Addendum No. 02

Power System Strengthening and Renewable Energy Integration Project – Package 1A: Constructions of Mirigama 220kV Switching Station, Mirigama 220/33kV Grid Substation and Peliyagoda 132/33 kV Grid Substation

**OCB No: CEB/AGM/PR/2024/OCB/PSSREIP-1A
(ADB Loan No. 4548-SRI)**

Drawing Title
PROPOSED LAYOUT FOR PELIYAGODA GRID SUBSTATION

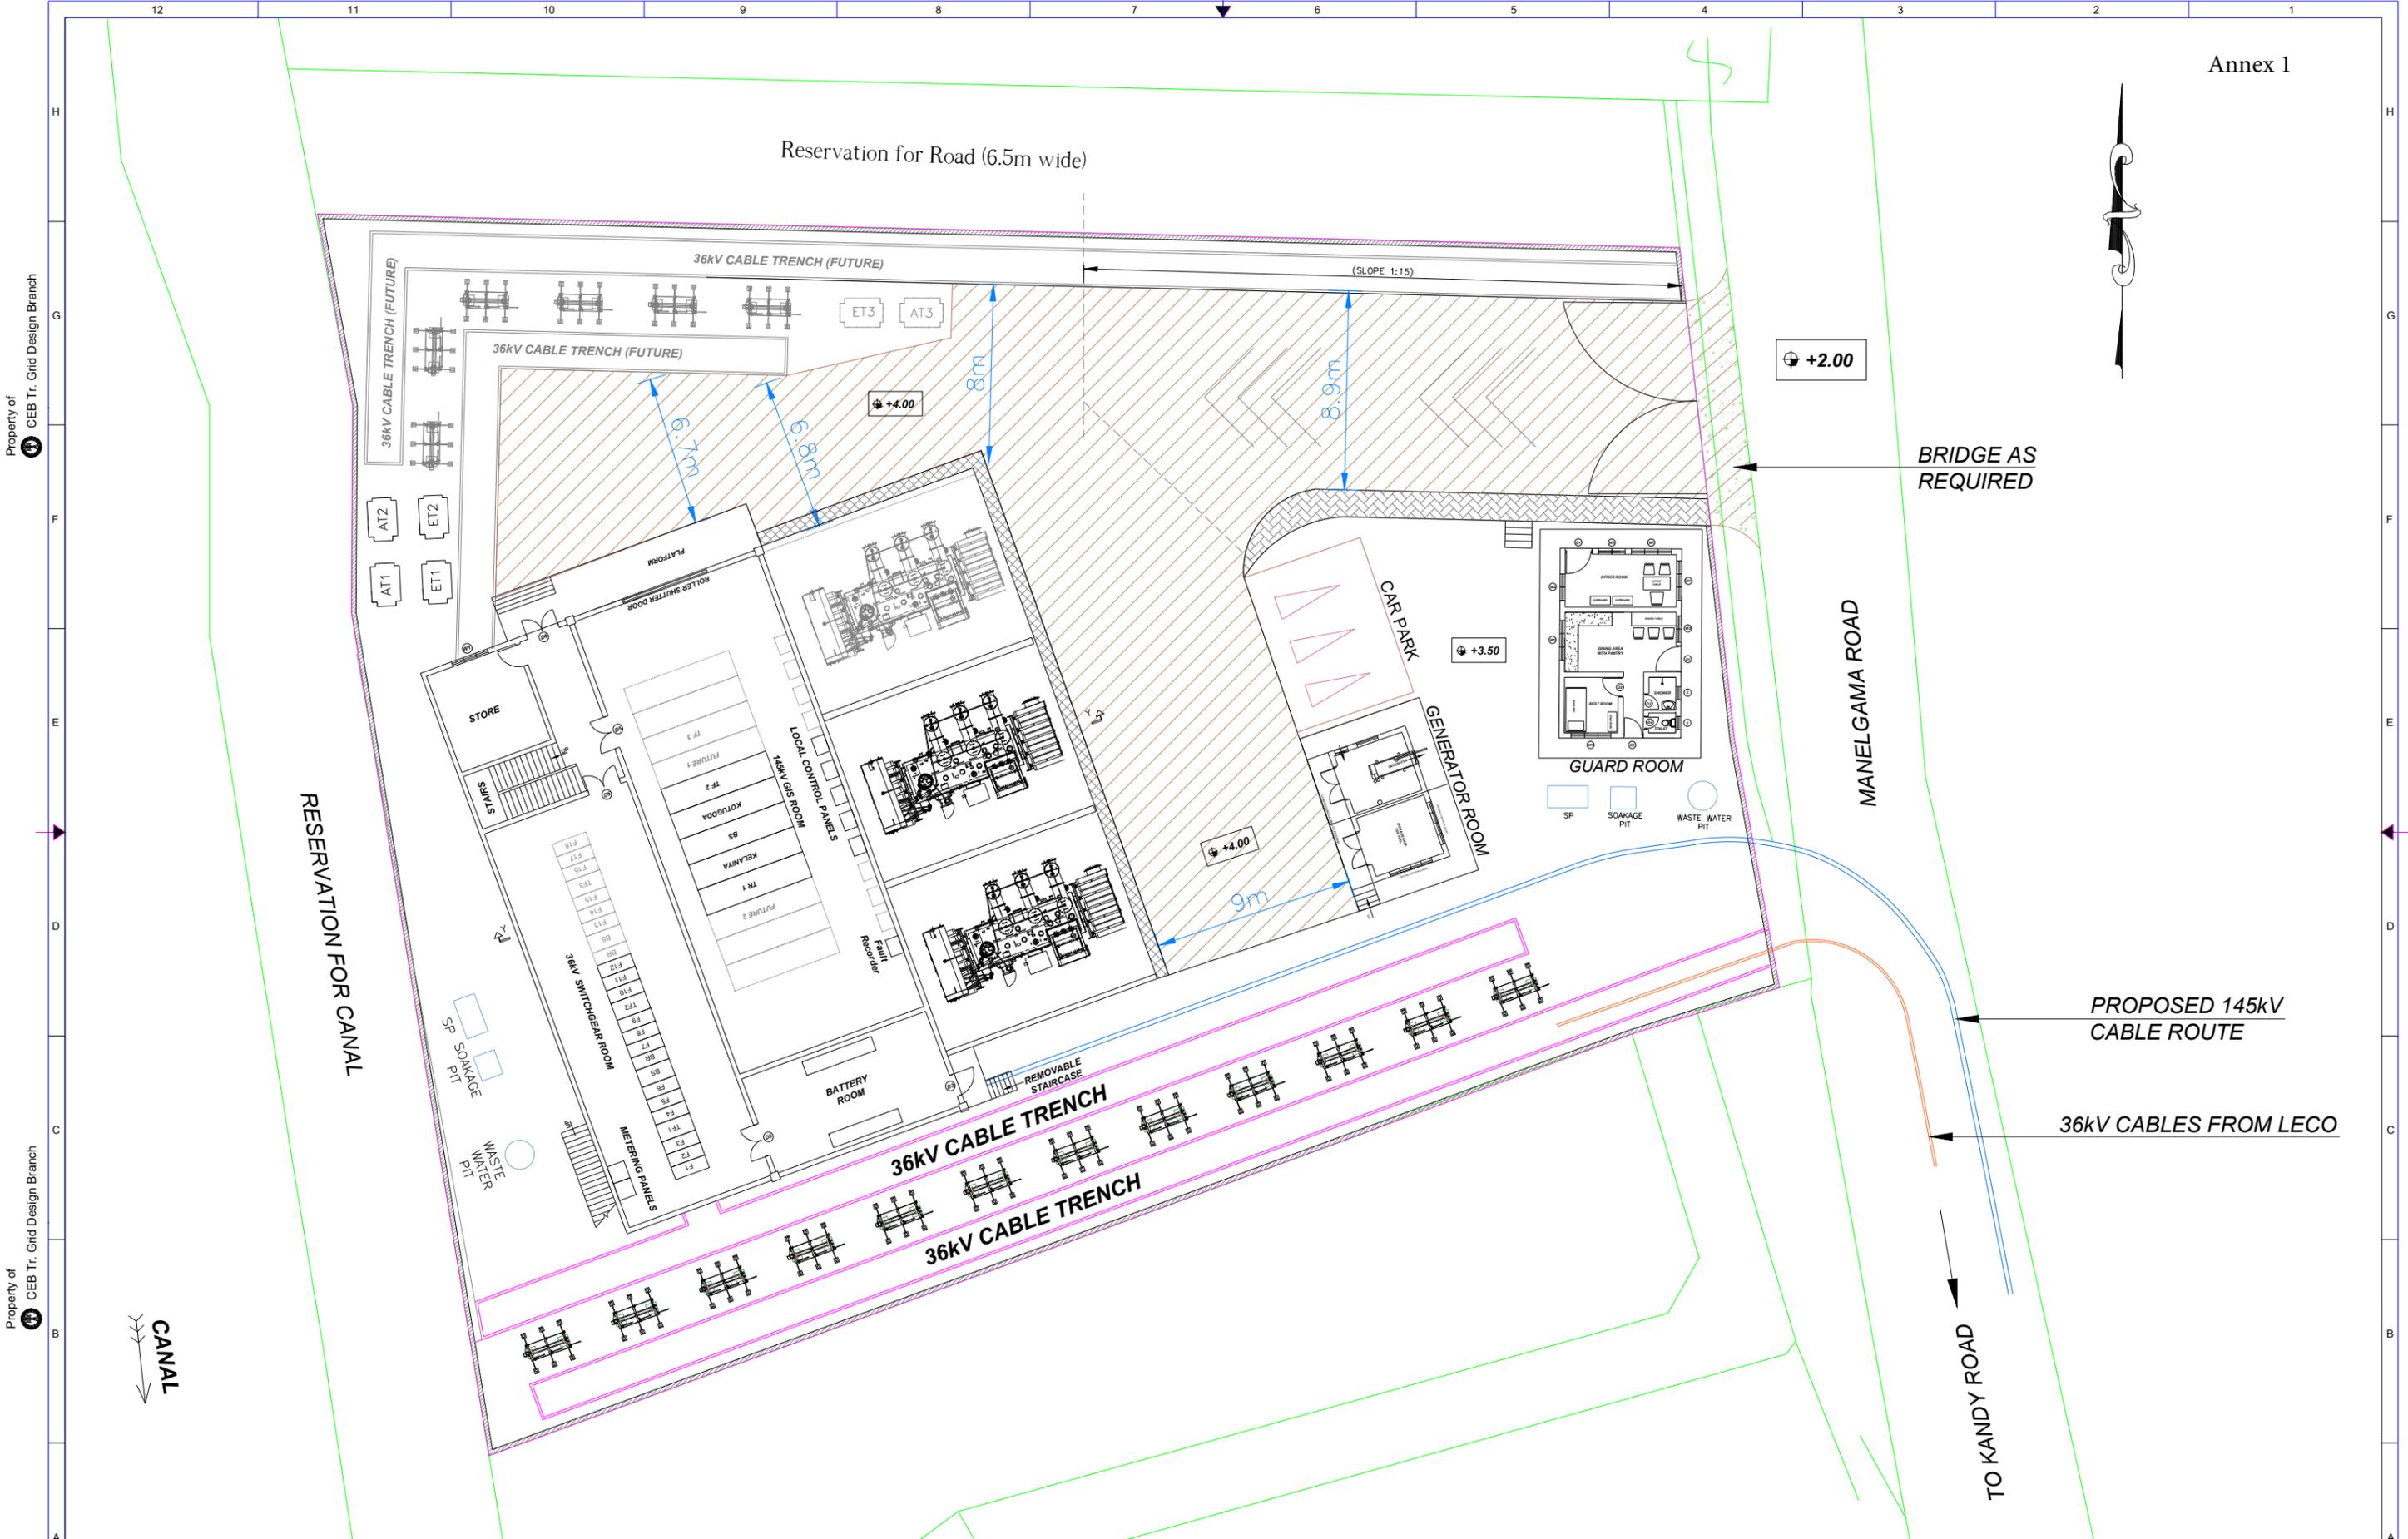
In consideration of the formation level and access road elevation at the Peliyagoda Grid Substation, the following drawings have been revised. Accordingly,

1. The Proposed Layout for Peliyagoda Grid Substation (Dwg No. TD/CE/1/257/D/01/02, Rev 0) in Section 6-Employer's requirement, Part C- Drawings in Volume 06 of 08 shall be replaced with Dwg No. TD/CE/1/257/D/01/02, Rev 1 (**Annex 1**)
2. The Proposed Control Building for Peliyagoda Grid Substation (Dwg No. TD/CE/1/257/D/60/02-A) in Section 6-Employer's requirement, Part C- Drawings in Volume 06 of 08 shall be replaced with Dwg No. TD/CE/1/257/D/60/02-A, Rev 1 (**Annex 2**)
3. The Proposed Section Drawing for Control Building of Peliyagoda Grid Substation (Dwg No. TD/CE/1/257/D/60/02-B) in Section 6-Employer's requirement, Part C- Drawings in Volume 06 of 08 shall be replaced with Dwg No. TD/CE/1/257/D/60/02-B, Rev 1(**Annex 3**)
